Appendix Ic of RNTPC
Paper No. A/YL-NSW/348B

**PROPOSED SOCIAL WELFARE FACILITY (RESIDENTIAL CARE HOME FOR PERSONS WITH
DISABILITIES) IN "VILLAGE TYPE DEVELOPMENT" ZONE ON APPROVED NAM SANG WAI
OUTLINE ZONING PLAN NO. S/YL-NSW/10 AT LOTS 3669 S.A RP (PART), 3669 S.B RP (PART),
3670 RP (PART) AND ADJOINING GOVERNMENT LAND IN D.D.104, NAM SANG WAI, YUEN LONG**

Town Planning Application No. A/YL-NSW/348 - Submission of Further Information (1)

**Proposed Social Welfare Facility (Residential Care Home For Persons With Disabilities) In “Village Type Development” Zone on Approved Nam Sang Wai Outline Zoning Plan No. S/YL-NSW/10 at Lots 3669 S.A RP (Part), 3669 S.B RP (Part), 3670 RP (Part) and adjoining government land in D.D.104, Nam Sang Wai, Yuen Long
(Planning Application No. A/YL-NSW/348)**

FIGURE 2.1
LOCATION OF REPRESENTATIVE AIR
SENSITIVE RECEIVERS

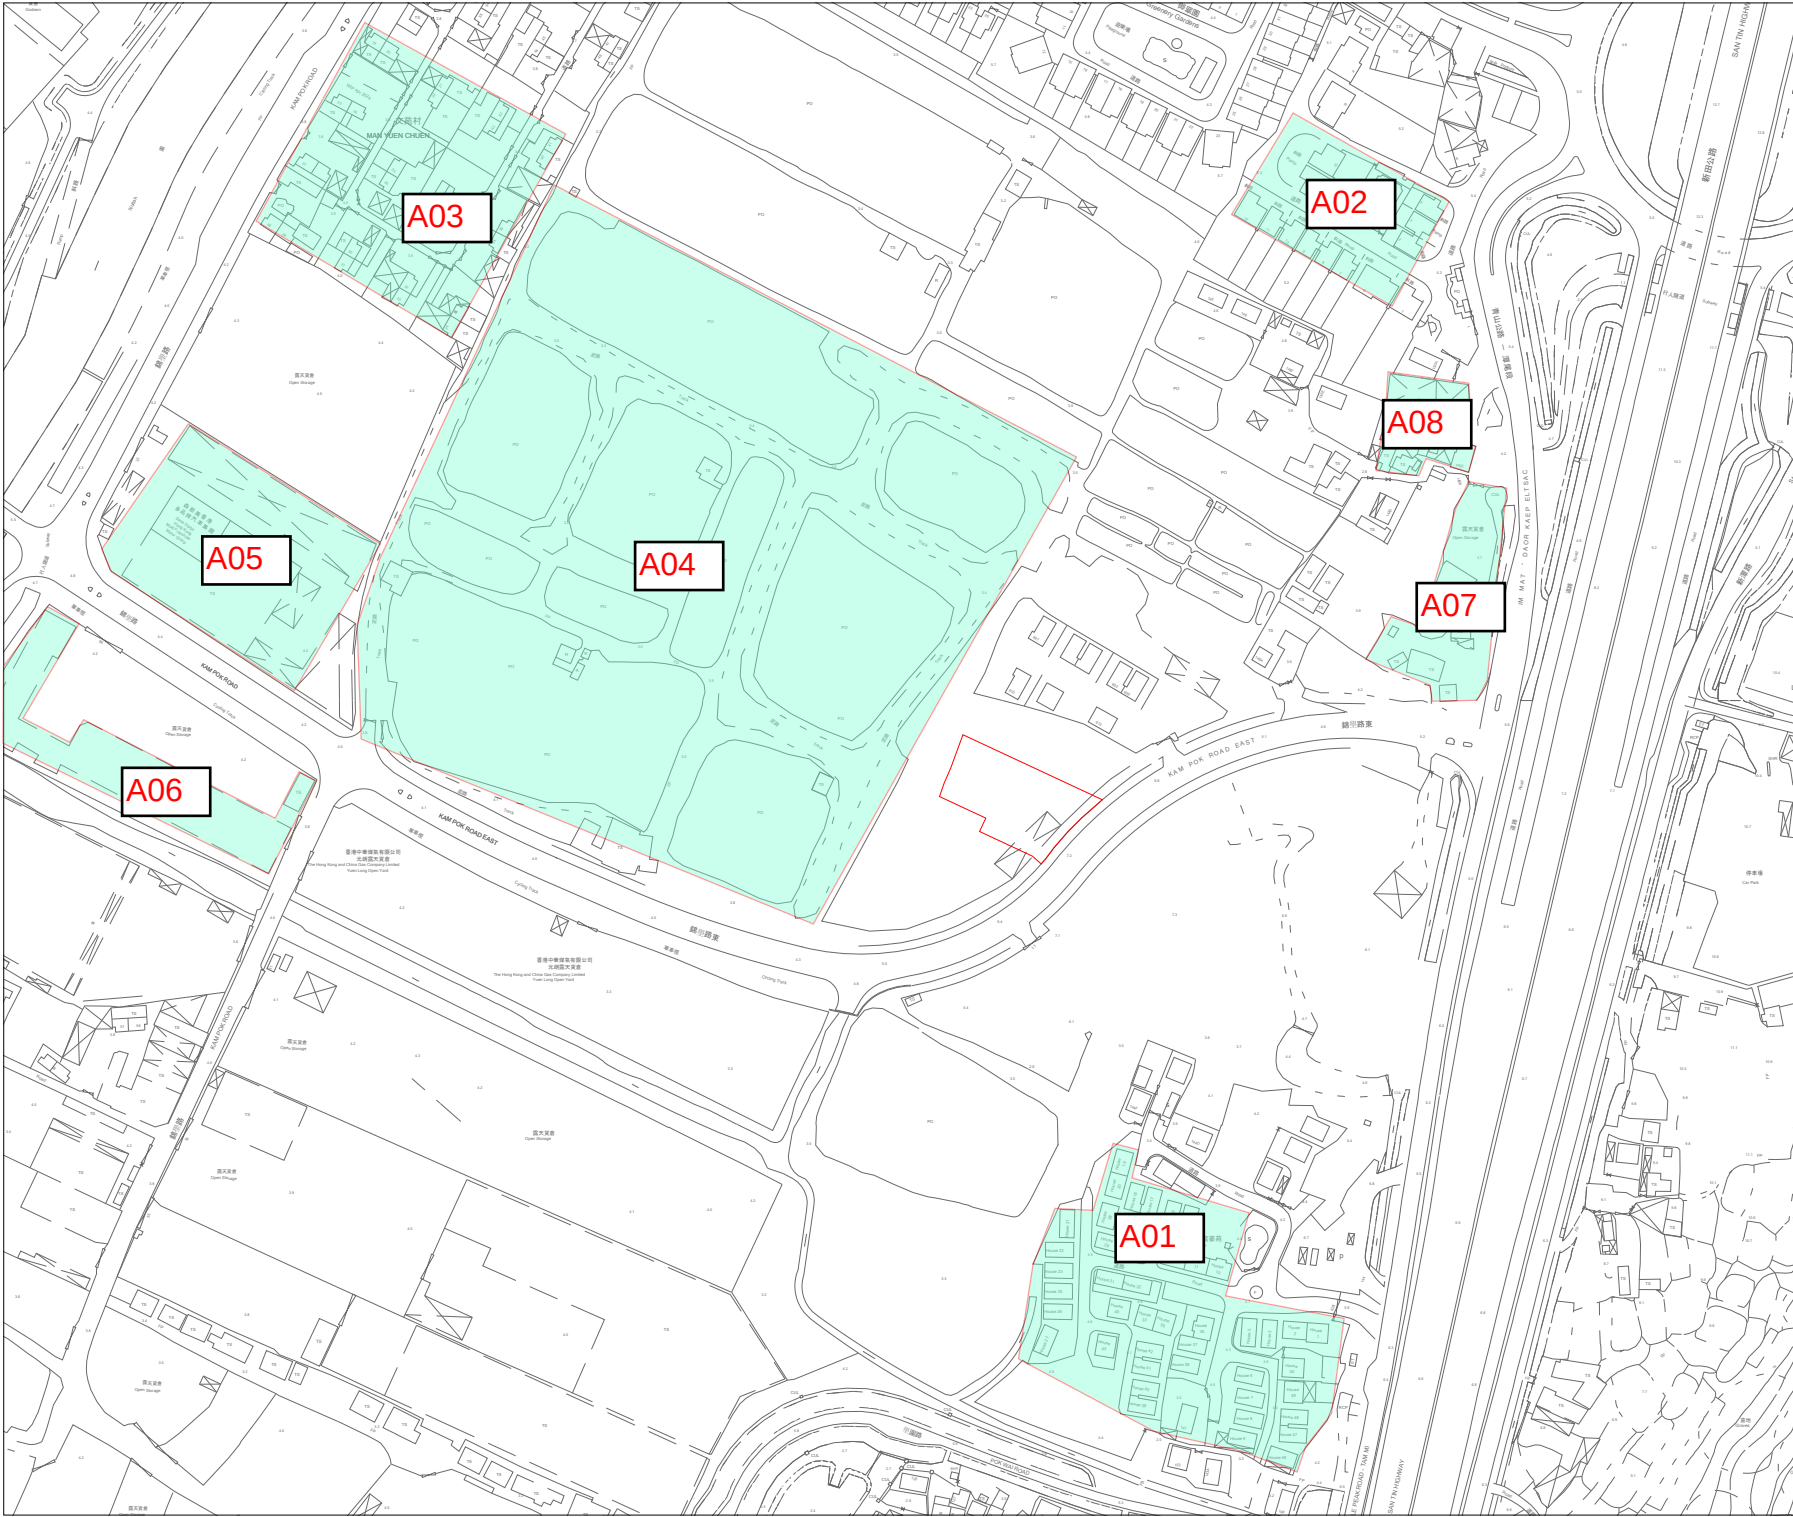
3. Section 2.3.1, Table 2.3 and Figure 2.1 - Please note that not only the domestic premises are the ASRs, some places/premises such as factory and workshop may also be the ASRs. Based on the desktop review, there are some areas in the vicinity of the project site which have been used for workshops/open storage, etc. Please review the potential existing/planned ASRs within the assessment area with reference to the Determination of ASR under the EIAO-TM and update as appropriate.	More ASRs have been identified in Table 2.3 and Figure 2.1. For other areas mainly for open storage use where long duration of exposure to air pollutants is not expected are, therefore, not considered as ASR.

FIGURE 2.2

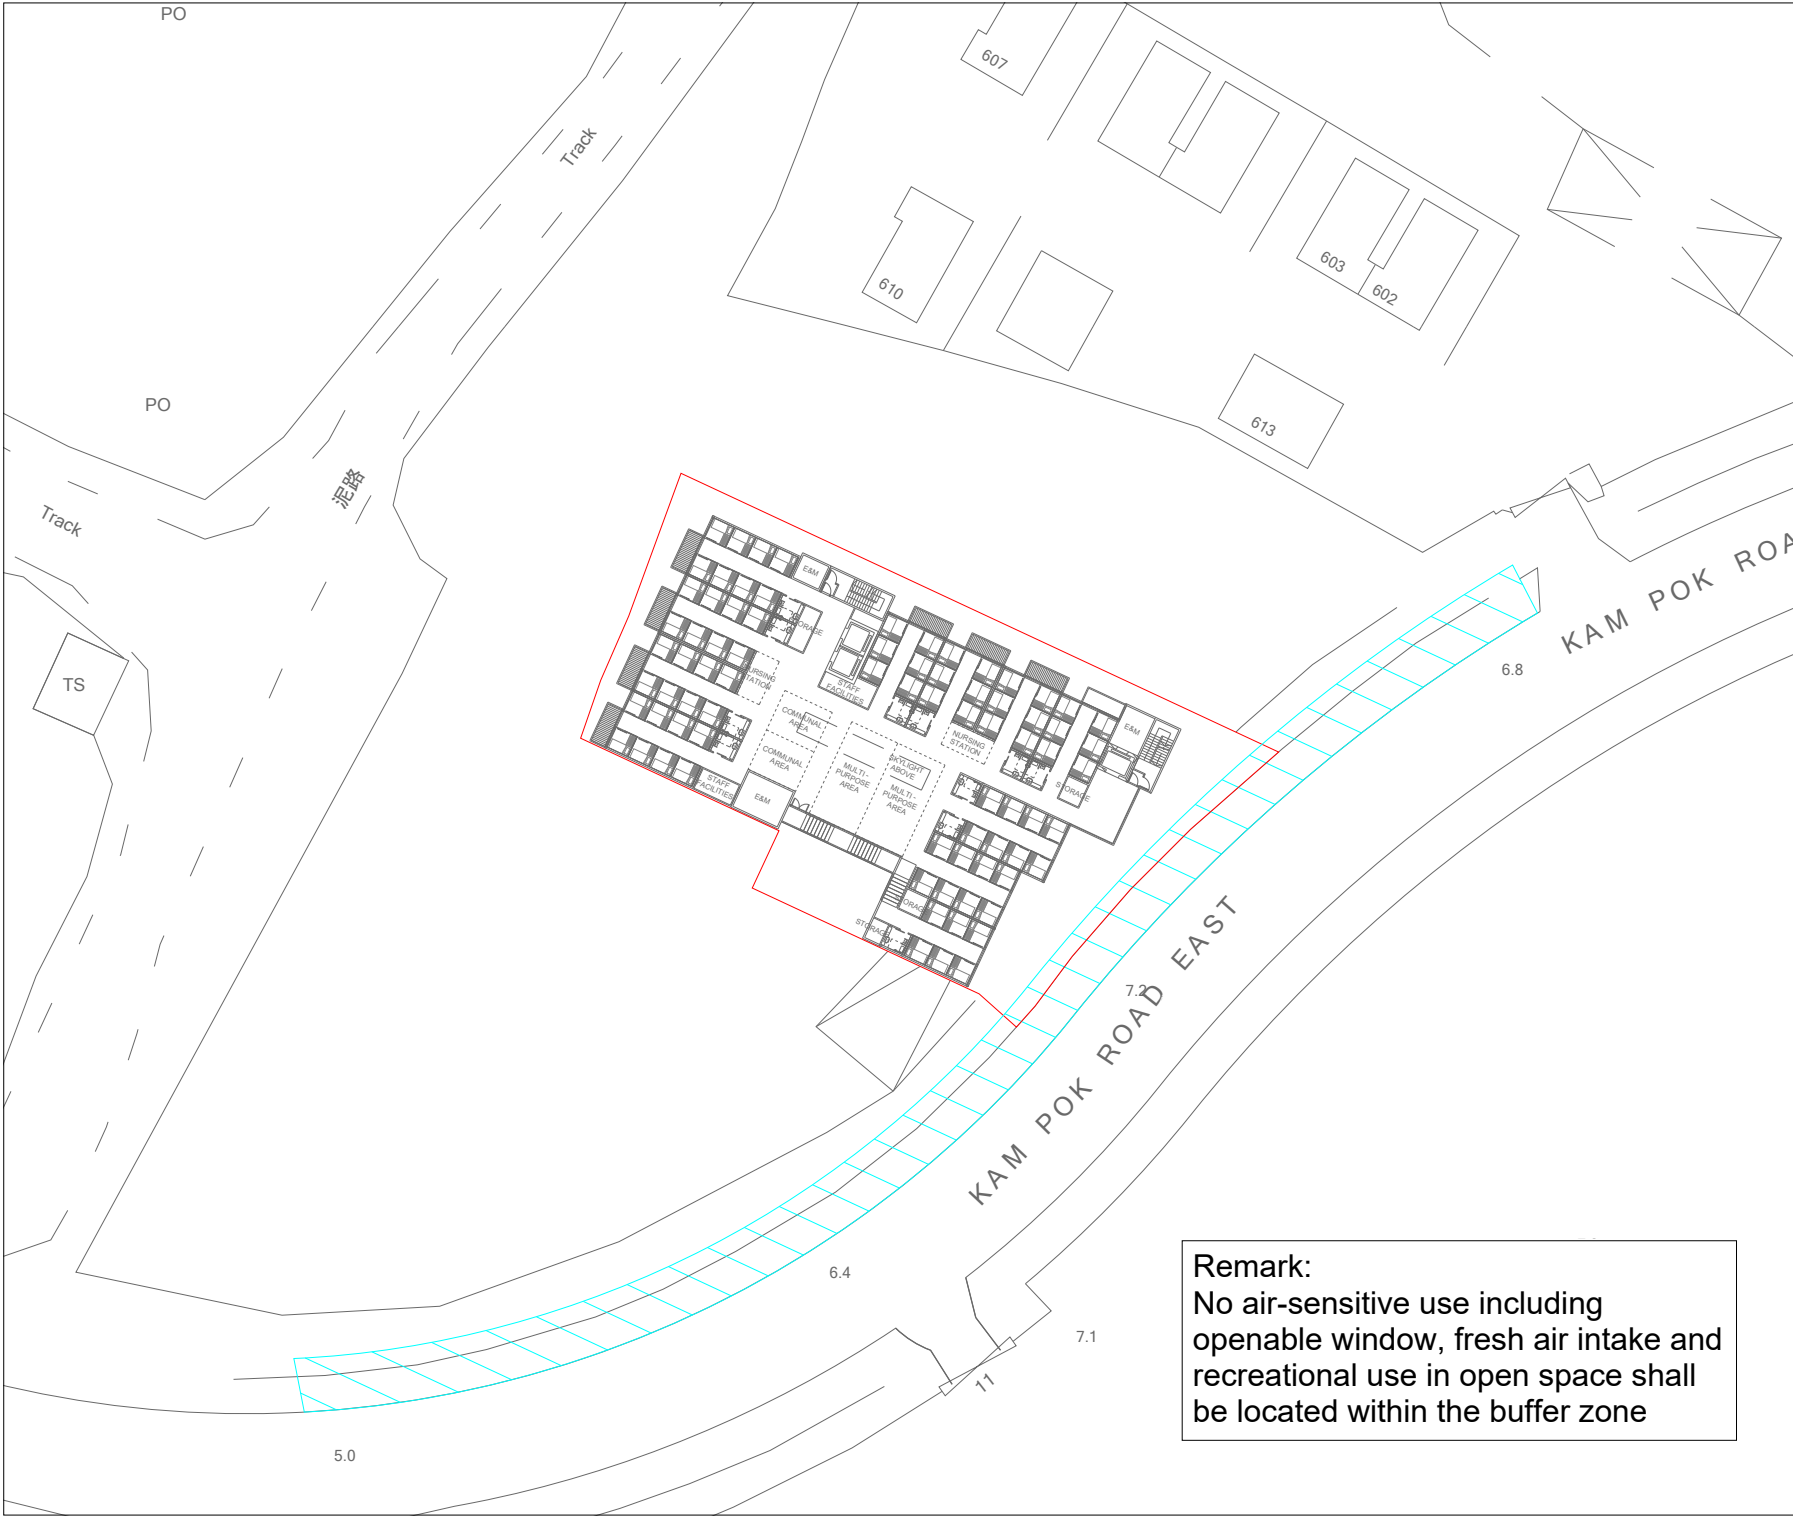
12. Figure 2.2 a. The buffer distance should be measured from the edge of road kerb. Please update and present the buffer zone appropriately. b. Please show the road name of Kam Pok Road East clearly in the figure. c. Please add a remark "No air-sensitive use including openable window, fresh air intake and recreational use in open space shall be located within the buffer zone".	Figure 2.2 is revised accordingly.
<u>Sewerage (Please refer to Appendix 2 for the revised SIA)</u>

Remark:
No air-sensitive use including openable window, fresh air intake and recreational use in open space shall be located within the buffer zone

FIGURE 2

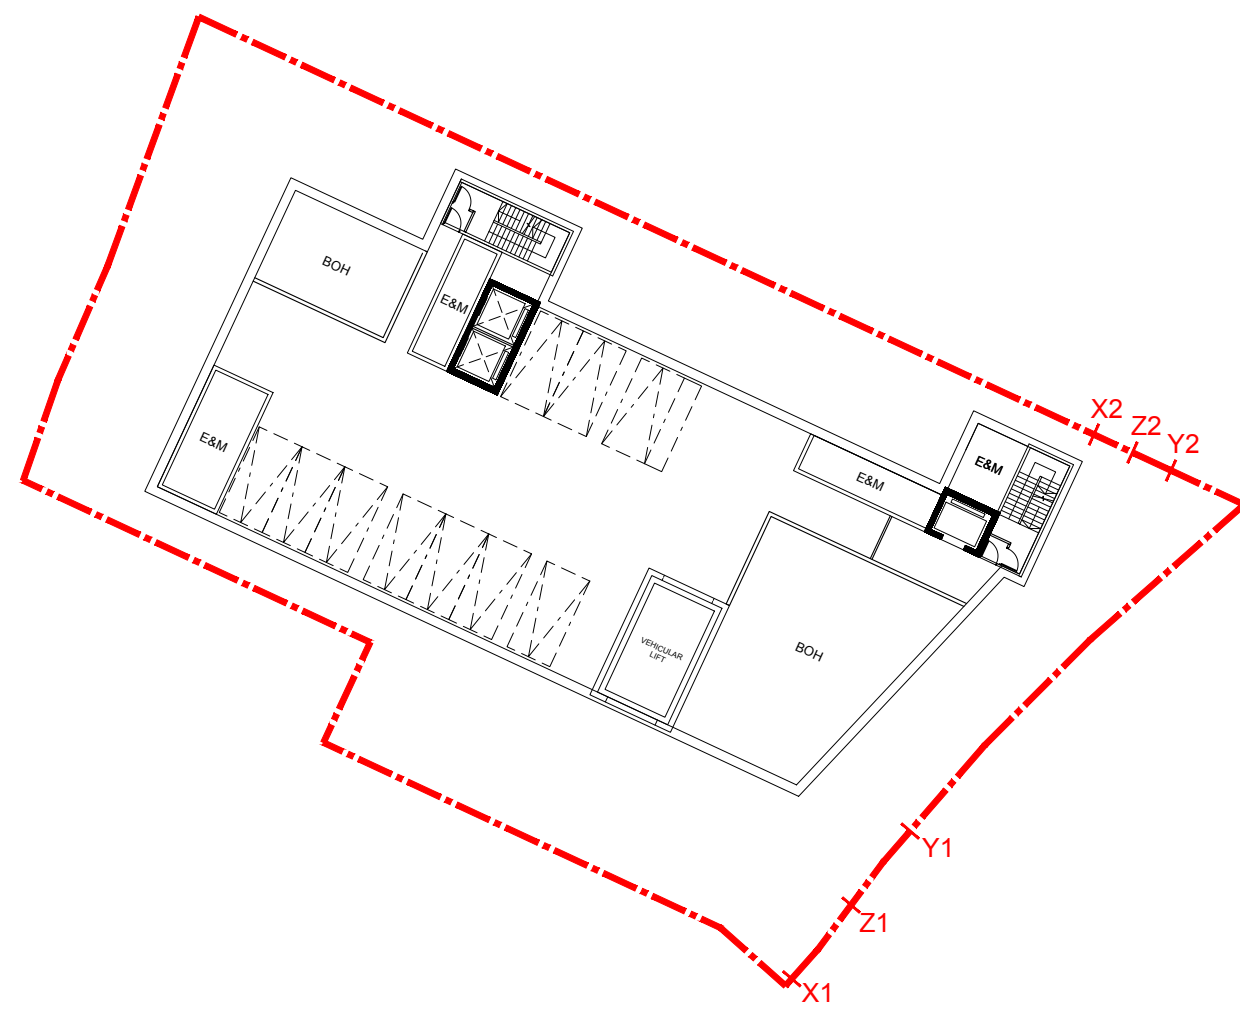
1. Para. 2.2.1 - Please check if the Figure 2 including existing sewerage record;	Figure 2 is supplemented.
2. Para. 2.2.2 - Please review "coube";	The typo is revised.

FIGURE 3

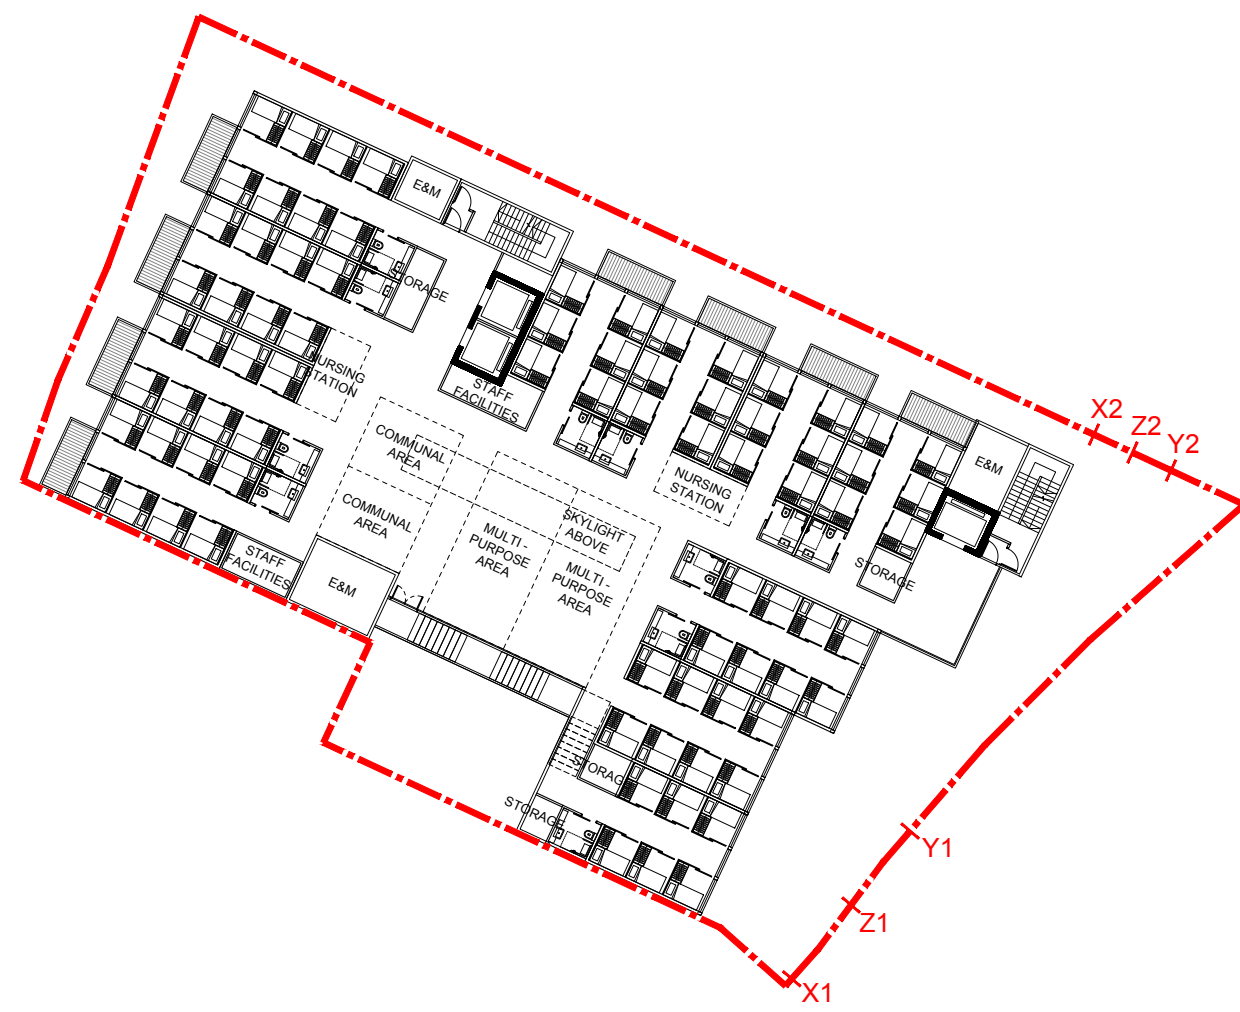
3. Figure 3 – Please indicate the pipes and manholes to be provided under the application and by others.	Figure 3 is updated accordingly.
4. Please provide the population intake year.	The population intake year is provided in Section 1.3.1.
<u>Email dated 4th July 2025 refers:</u> <u>Drainage Services Department (Comments on the SIA)</u> <u>(Please refer to Appendix 2 for the revised SIA)</u>

5. Please advise who will implement and maintain the proposed sewerage system/facilities. Please discuss in the report text and prepare a drawing for comment; and	Figure 3 is updated to include liability of implementation and maintenance. Detailed discussion refer to Para 2.2.2 and 2.2.3.

6. Figure 3 - Please indicate all cover levels. Please note that the cover level(s) of terminal manhole(s) should be higher than that of the downstream public manhole(s). Please include the above in report text and drawing remark.	The cover levels has included in Figure 3. Report text is provided in Para.2.2.3.
<u>Email dated 27th June 2025 refers:</u> <u>Architectural Services Department</u>	
Please provide photomontages of the proposal in its surrounding context from different vantage points.	The proposal in its surrounding context could be seen from 2 different vantage points as demonstrated by the photomontages attached in Appendix 3.
